**From:** [Whittaker, Roberta \(EXT\)](#)  
**To:** [Johnston, Christopher](#)  
**Cc:** [Planning \(SMDC\)](#)  
**Subject:** RE: SMD/2021/0491 - Land off Tenford Lane - LLFA Response (Rev 9)  
**Date:** 19 December 2022 15:30:00  
**Attachments:** [image002.png](#)  
[image003.png](#)  
[image004.png](#)  
[image001.png](#)  
[image005.png](#)

Thank you for reconsulting us on the RM application SMD/2021/0491 – Land off Tenford Lane.

### **Staffordshire County Council Flood Risk Management Position**

Figure 13.4 Plan view of infiltration basin

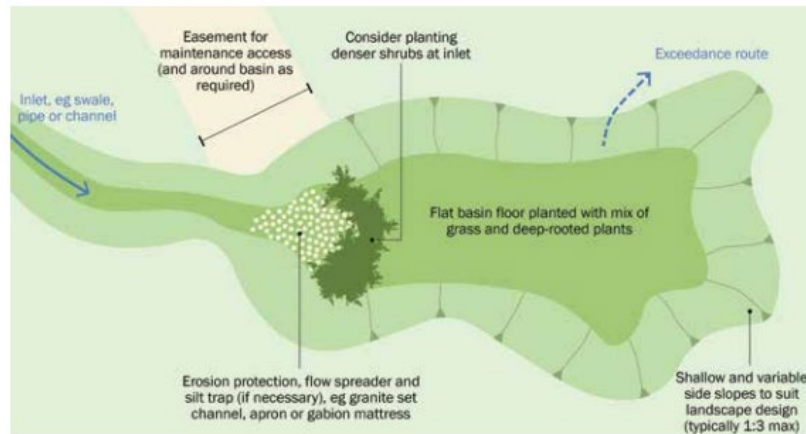
Need to see landscaping plans for the swale to ensure infiltration potential is optimised with planting and to show how erosion will be prevented.

We're looking for something like this example in the SuDS Manual:
